PB# 87-8

TOWN OF NEW WINDSOR
PLANNING BOARD
REVIEW COMMENTS

PROJECT NAME: RIZZO AND RIGNEY SITE PLAN
PROJECT LOCATION: WEATHER OAK HILL ROAD AND ROUTE 207
NEW WINDSOR #: 87-08
13 APRIL 1988

RIZZO AND RIGNEY SITE PLAN (87-8) CUOMO

Patrick T. Kennedy L.S. 335 Temple Hill Road - New Windsor, New York 12550		
SCALE: 1" = 20'	APPROVED BY:	DRAWN BY:
DATE: Sept 8, 1986		REVISED: Dec 7, 1987
Site Plan for Angelo Rizzo & Lorraine Rigney Town of New Windsor Orange County, New York		
DRAWING NUMBER 87-664

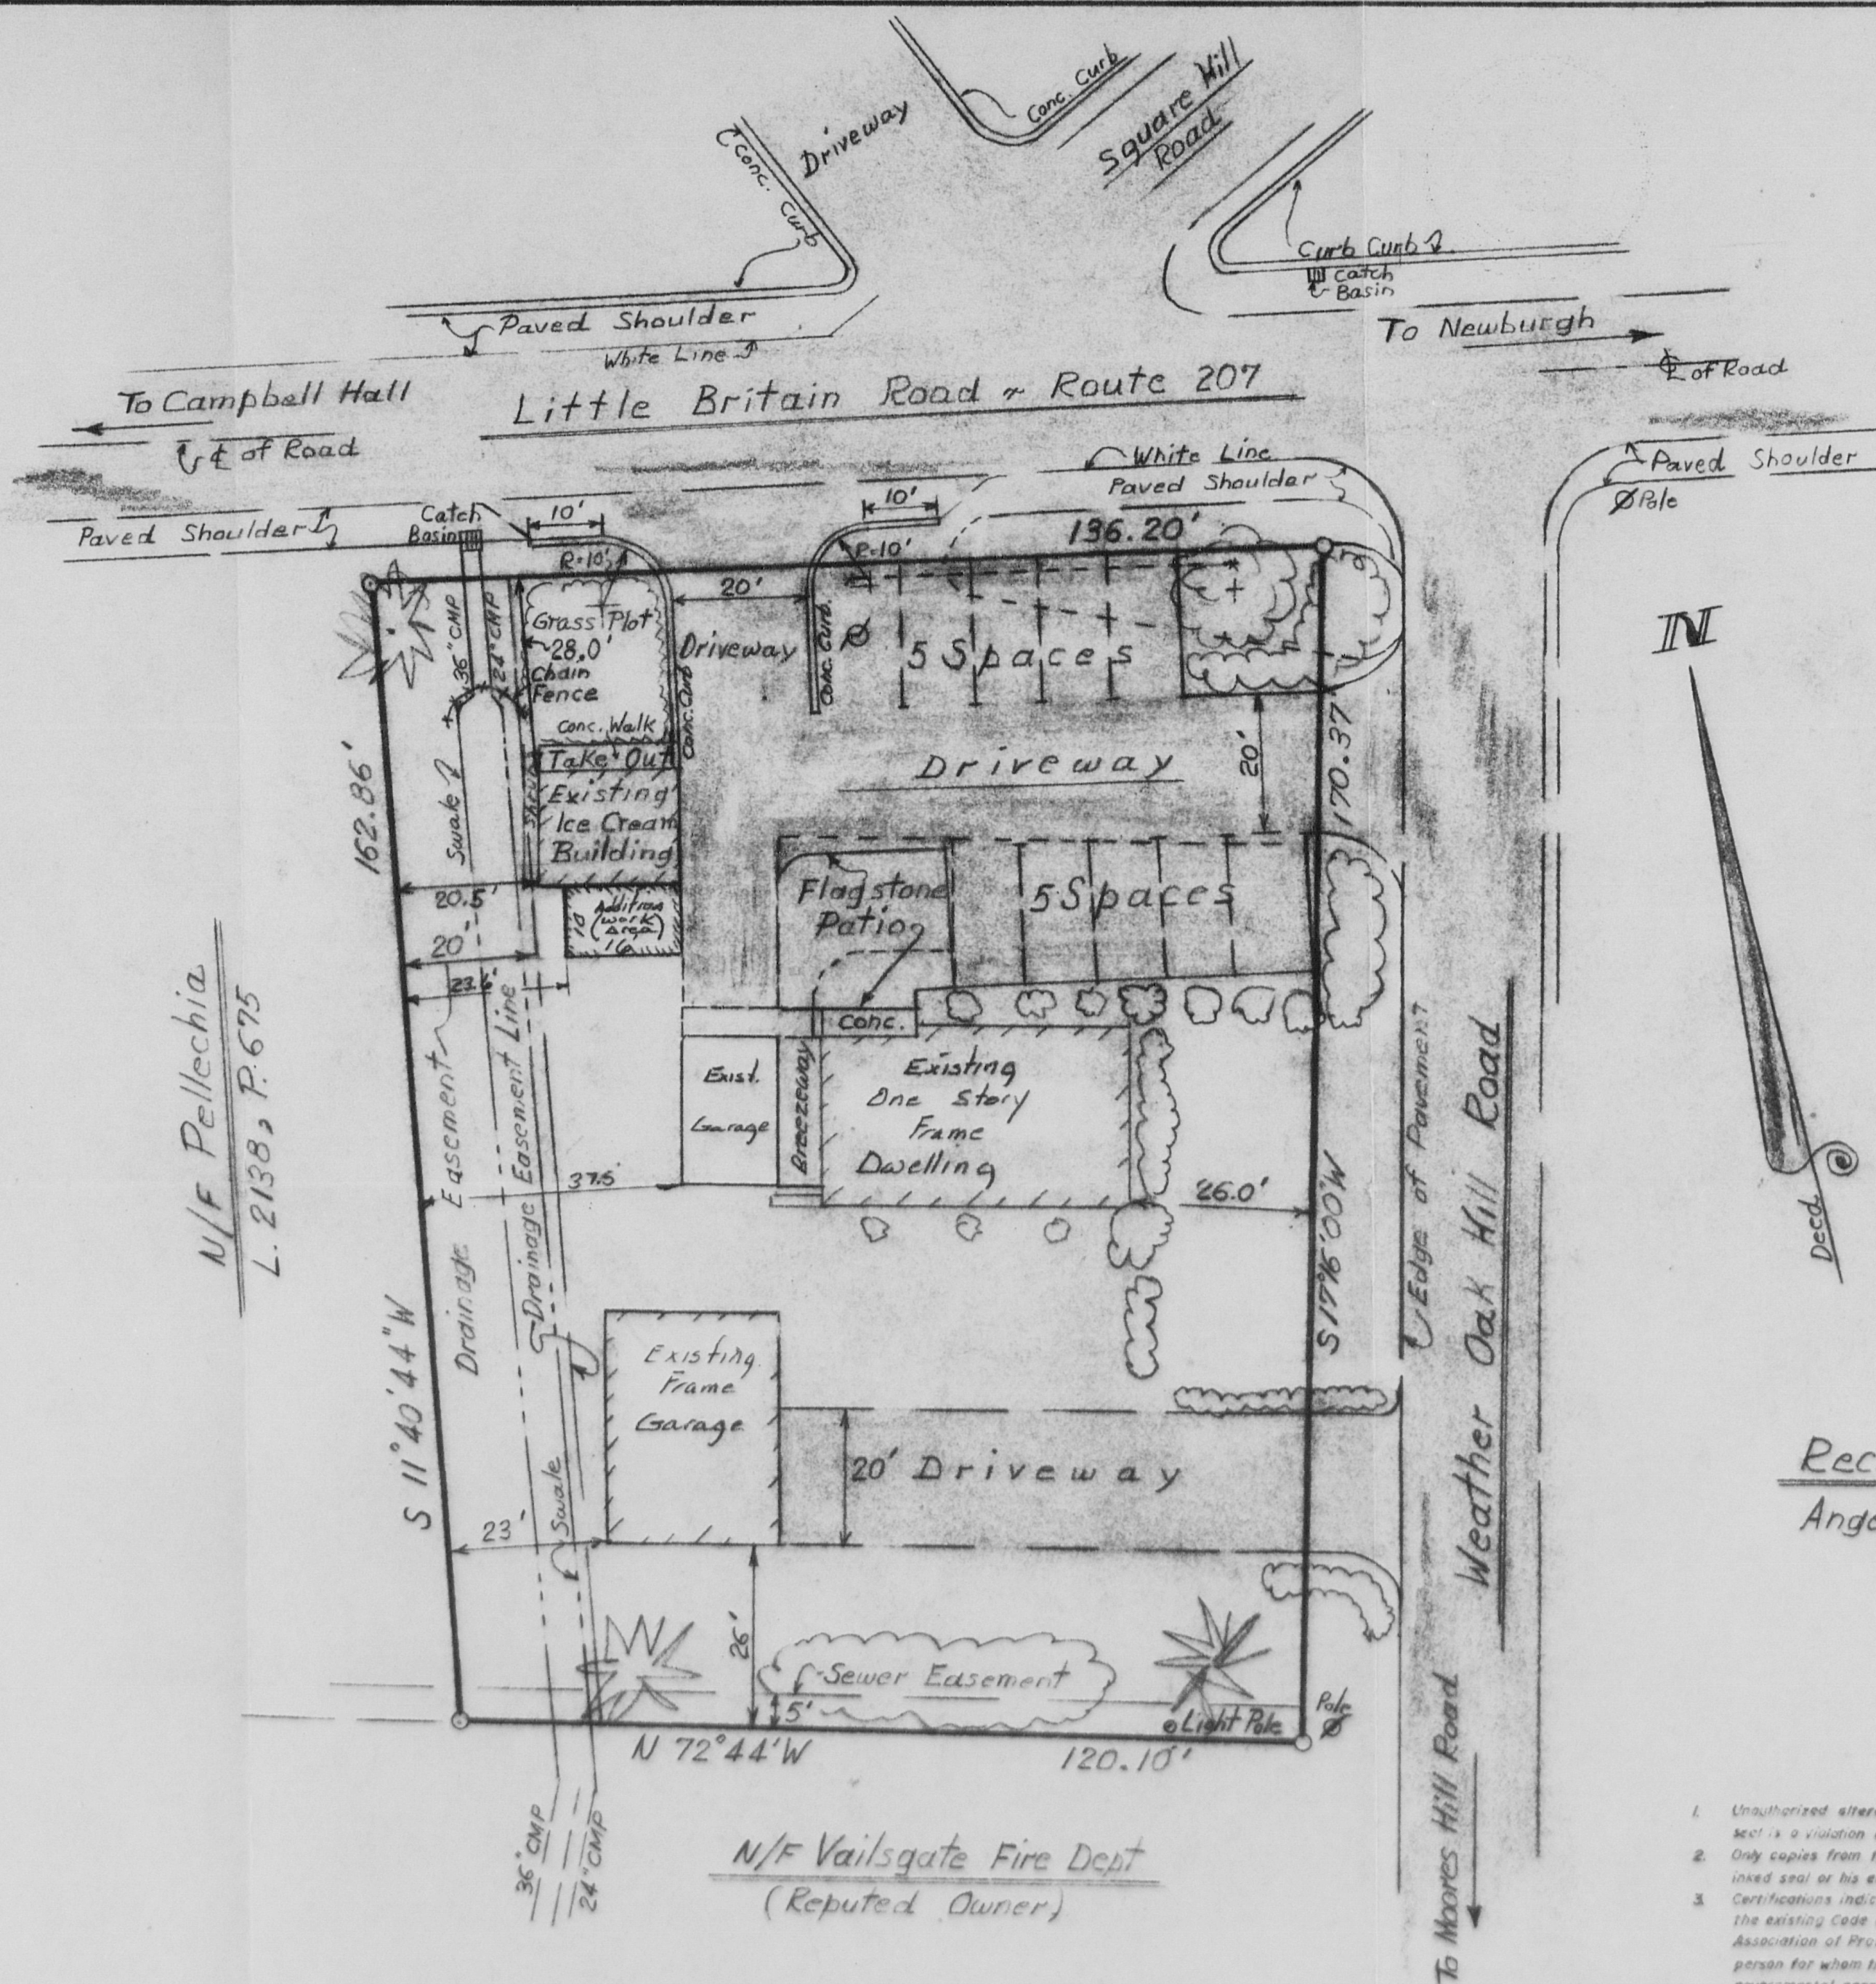
1). The Applicant has submitted a Site Plan for review which proposes the construction of a 10'x 16' addition to the existing "Ice-cream building" of the site. This plan was previously reviewed at the 13 January 1988 and 23 March 1988 Planning Board meetings.

2). It is my understanding that the New York State Department of Transportation has indicated that no approval or submittals are required for the existing site driveway onto Route 207. This should be verified.

4). Inasmuch as the Site Plan includes only the enclosure of an existing slab as an addition to an existing structure, and same has been found acceptable by the various Town Departments, it is my opinion that the addition is acceptable from an engineering standpoint. The Board may wish to further discuss the conditions with regard to the existing parking area surface, access drives, etc.. In addition, the Board may wish to discuss with the Applicant the fact that further "crowding" of this site would be undesirable.

1. The Applicant has submitted a Site Plan for review which proposes the construction of a 10 foot by 16 foot addition to the existing "Ice Cream Building" of the site. This plan was previously reviewed at the 13 January 1988 Planning Board meeting. A different version of the plan was reviewed at the 22 April 1987 Planning Board meeting.

2. The Site Plan as submitted and reviewed by various Departments currently has several disapprovals. In addition, the New York State Department of Transportation has indicated that the 20 foot drive is not acceptable and that the application must be reviewed by the Regional Office. It is my recommendation that prior to Planning Board approval, all Departments be further consulted such that any necessary revisions can be made.

It is my understanding that the only change and/or addition for this Application involves the enclosure of the patio area. If this is the case, it should be verified that all other site conditions have previously been submitted and approved, including the "Highway Curb Cut".

4. I find the overall Site Plan for this project extremely crowded. Other than enclosing the patio area as a work area for the business, I would not recommend any further development of the site. In fact, it may be worthwhile discussing with the Applicant any possible parking and driveway improvements which can be made.

A 20' DRIVE WILL NOT BE ALLOWED. WHY CAN'T
THEY ENTER & EXIT ONTO WEATHER OAK HILL ROAD

TABLE I-770 OF TITLE 9 REQUIRES A MINIMUM OF FIFTEEN FEET BETWEEN BUILDINGS WITH COMBUSTIBLE WALLS WITH COMBUSTIBLE EXTERIOR FINISHES

Installation of ~~pp~~ pipe on 2 driveways off Weather
Oak Hill Rd.

3). The Board should note that the plan has been disapproved by the Bureau of Fire Prevention reflective of the fact that the proposed addition would not provide minimum required spacing between structures.

Mr. VanLeeuwen: I make a motion that the Planning Board of the Town of New Windsor approve the Rizzo and Rigney site plan with the parking area shown as blacktopped by June 30, 1988.

Mr. VanLeeuwen: I will change my motion till July 30th.

Building plans revised and to be non-combustible construction
Plans are now acceptable
